# CONSTRUCTION PLANS FOR THE HILLS AT LORSON RANCH FILING NO. 3

## STREET & STORM SEWER CONSTRUCTION PLANS

**THE RIDGE AT LORSON RANCH FIL NO. 3  
STREET & STORM SEWER  
CONSTRUCTION PLANS**

DATE: NOV, 2021  
 PROJECT NO. 100.068  
 SHEET NUMBER C6.37  
 TOTAL SHEETS: 18

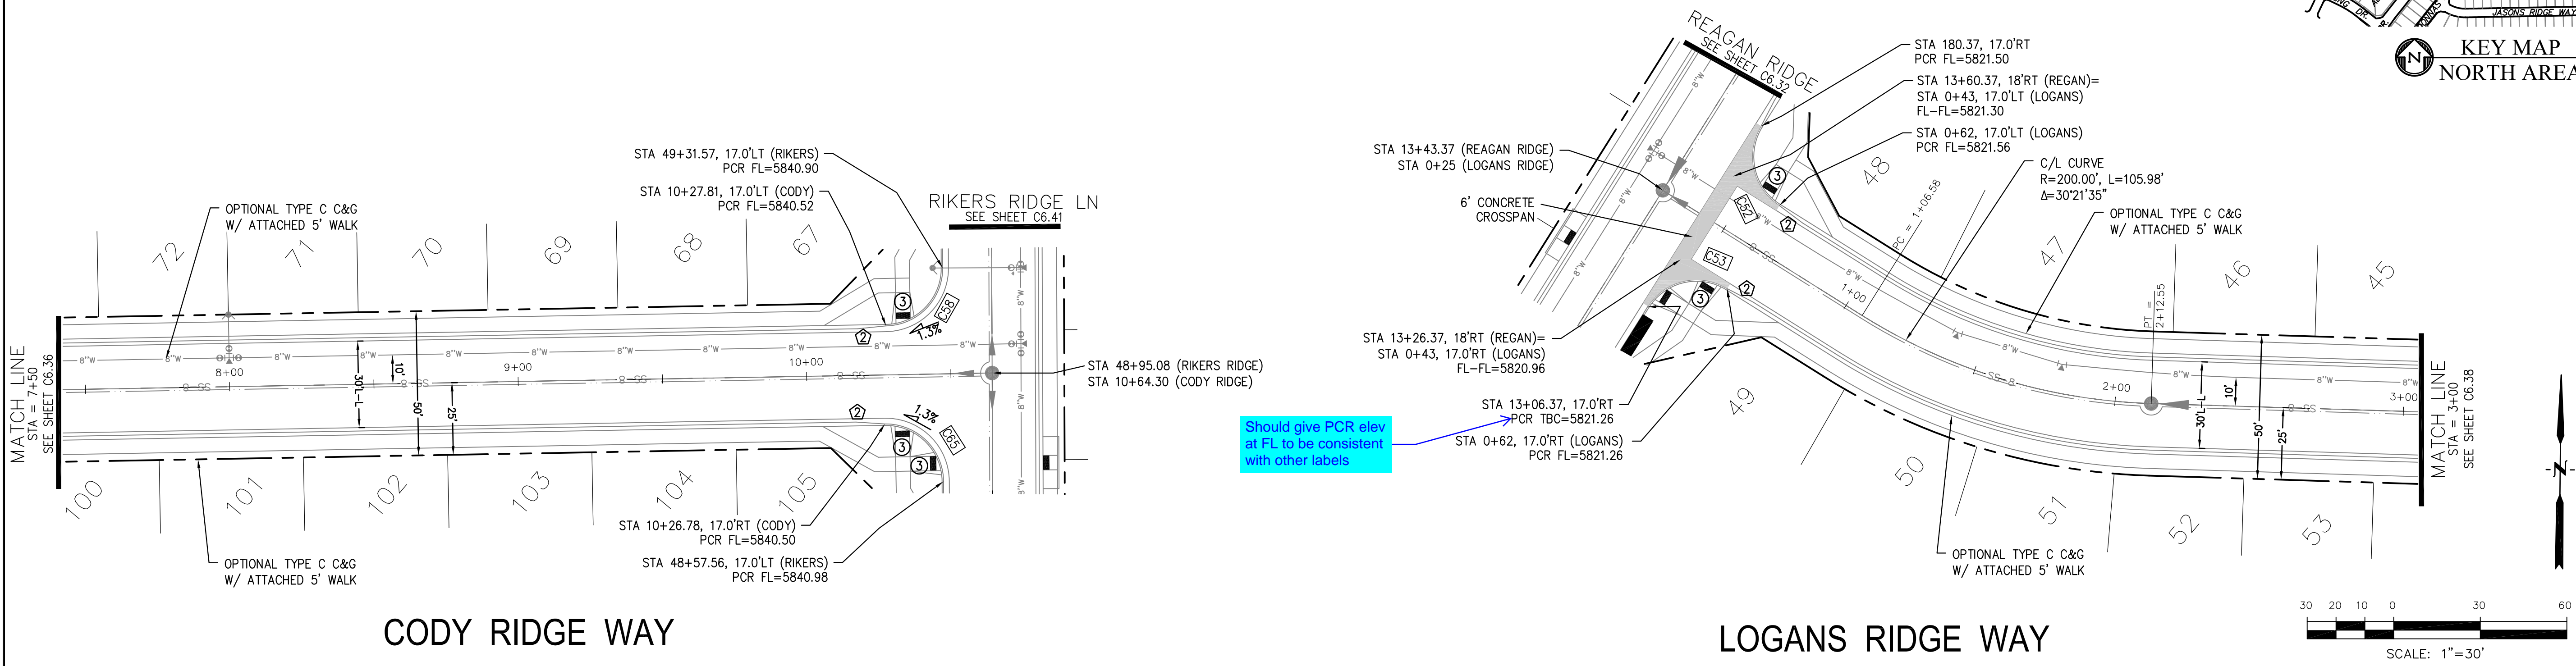
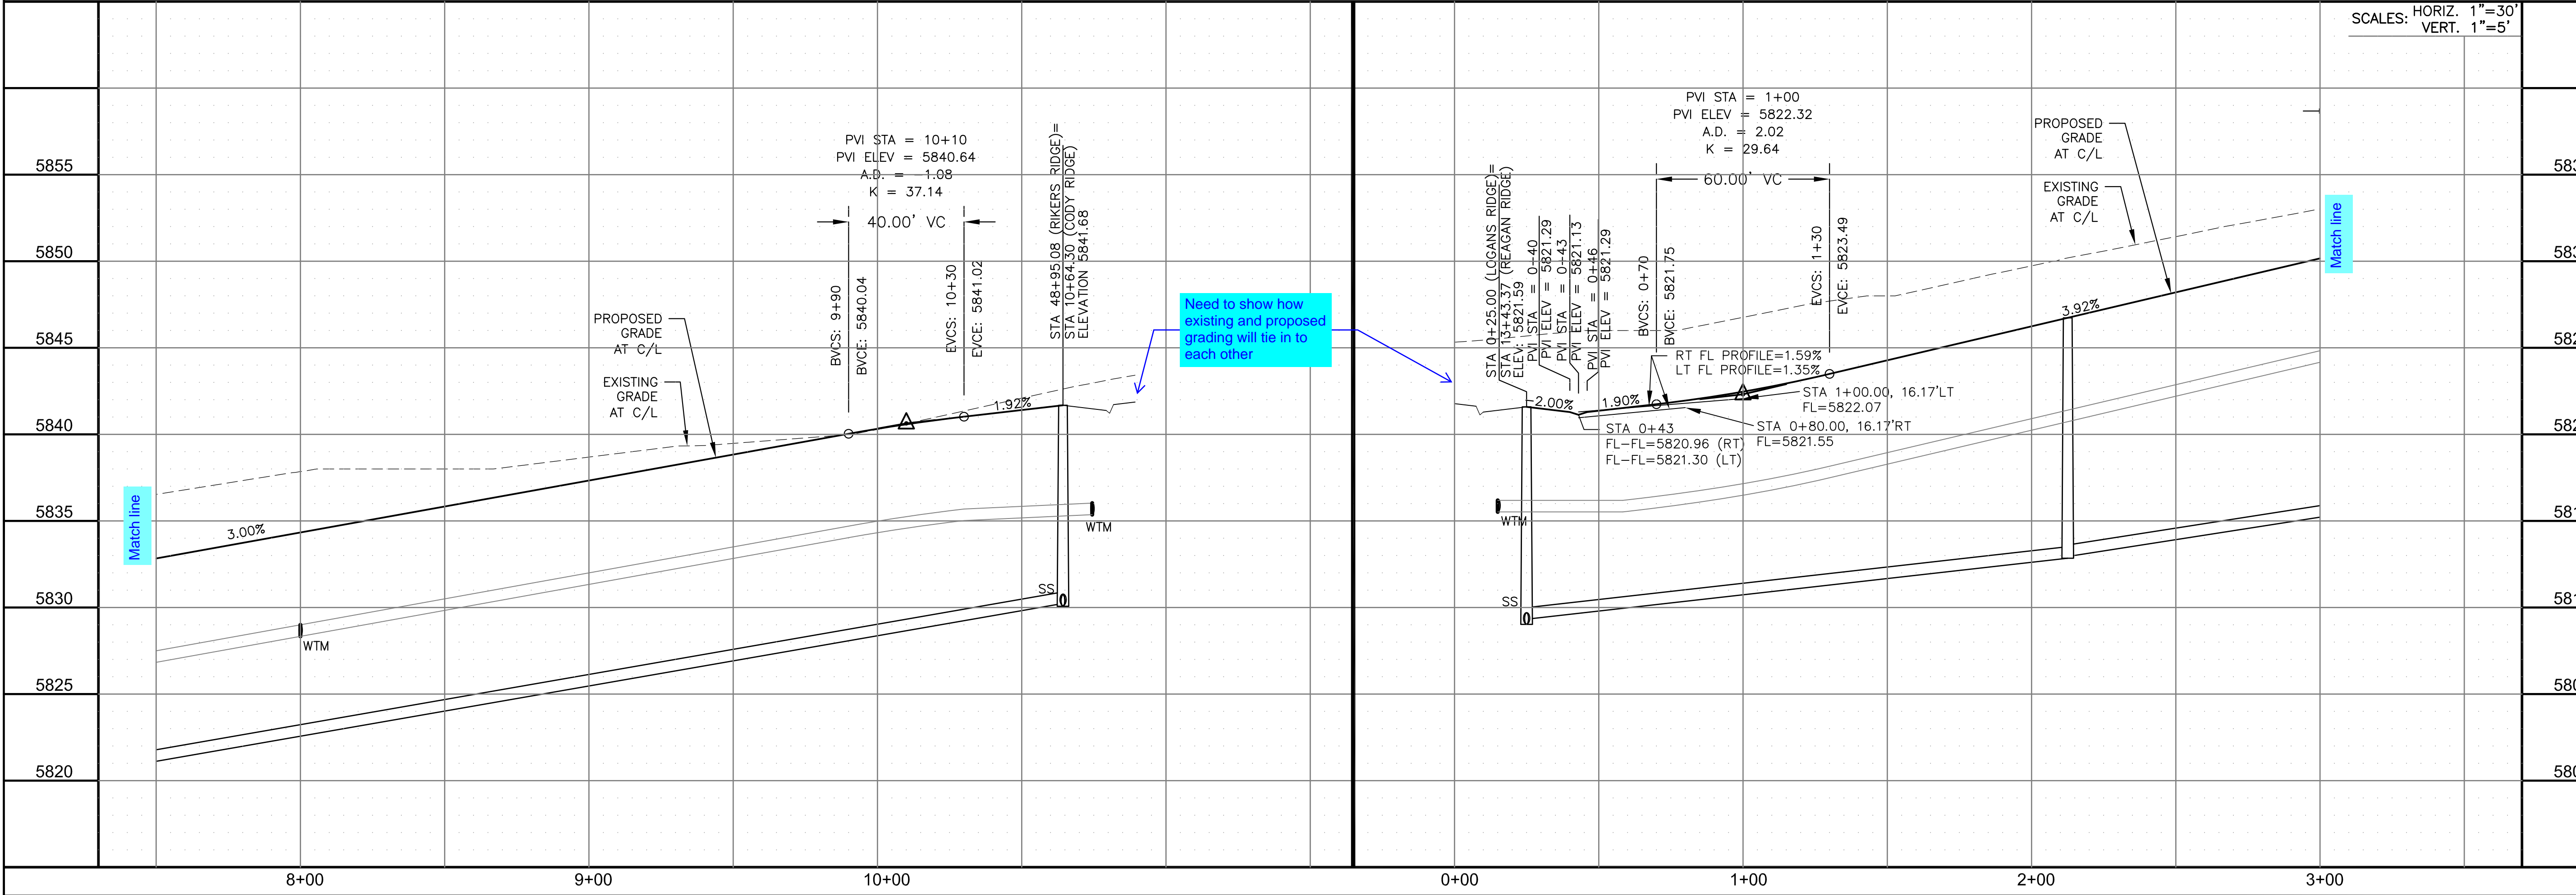
Should give PCR elev at FL to be consistent with other labels

Need to show how existing and proposed grading will tie in to each other

SHEET NUMBER C6.38

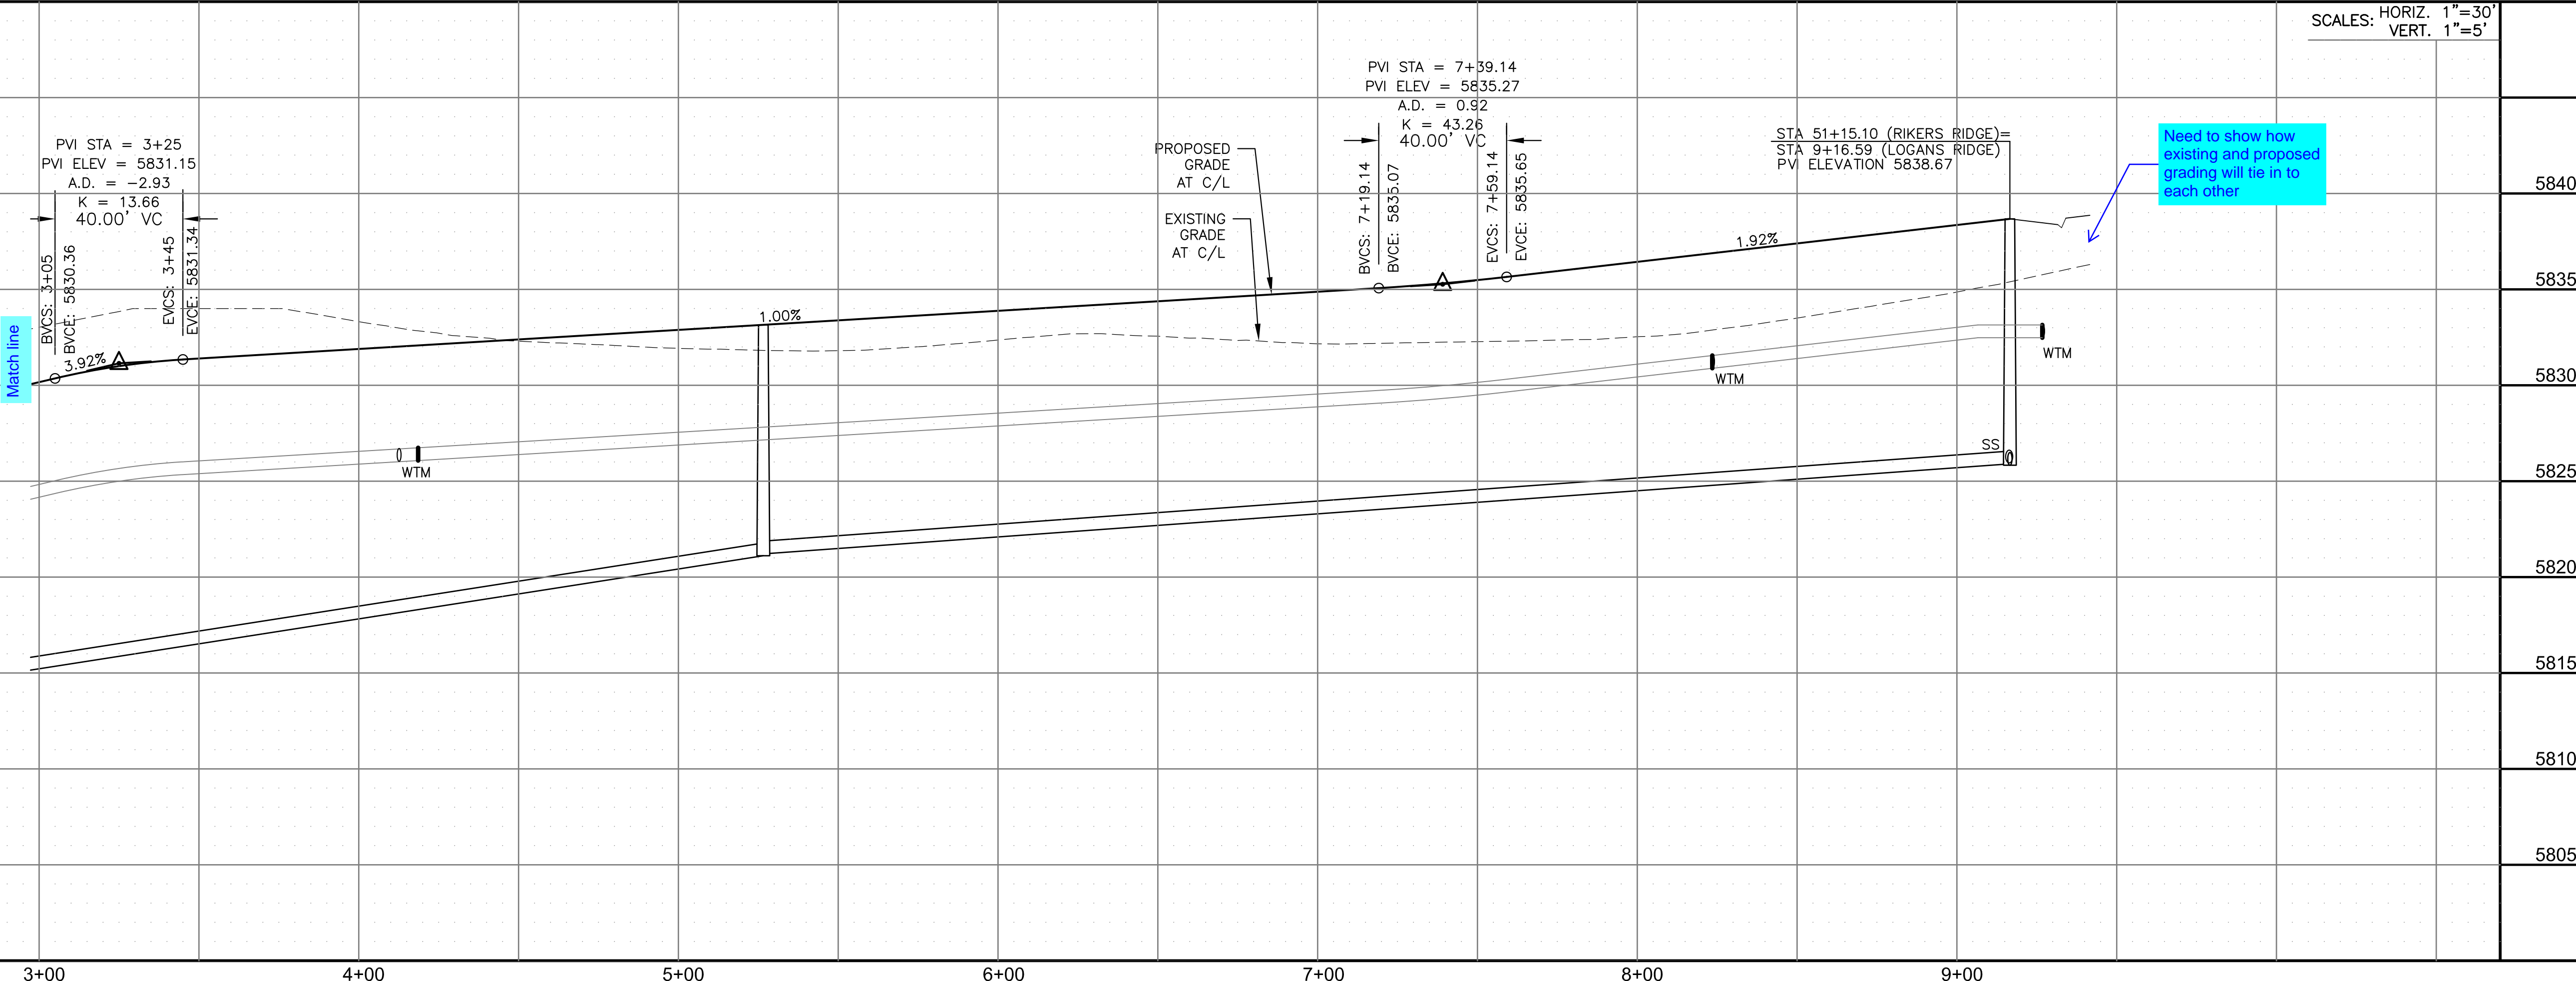
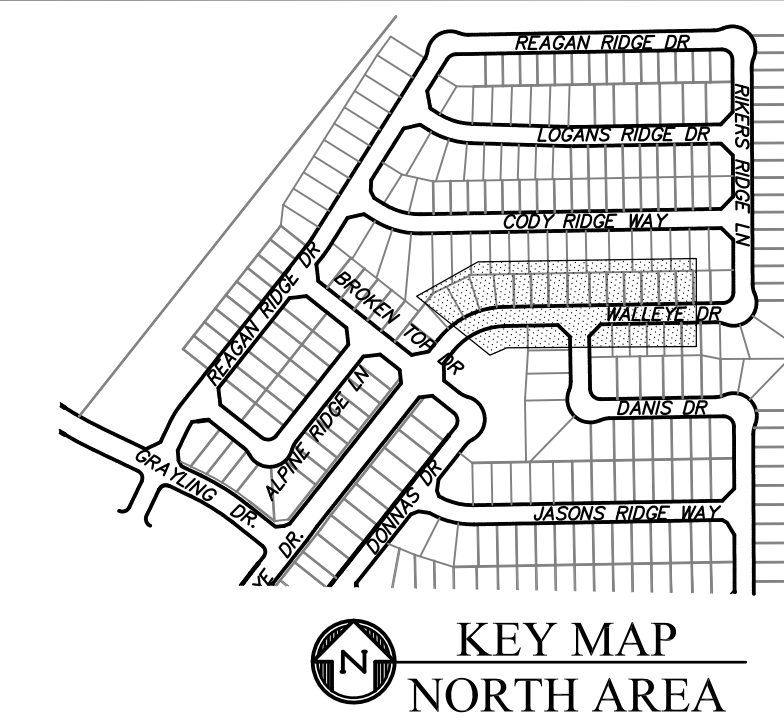
Table not needed as all curves are within Filing 2
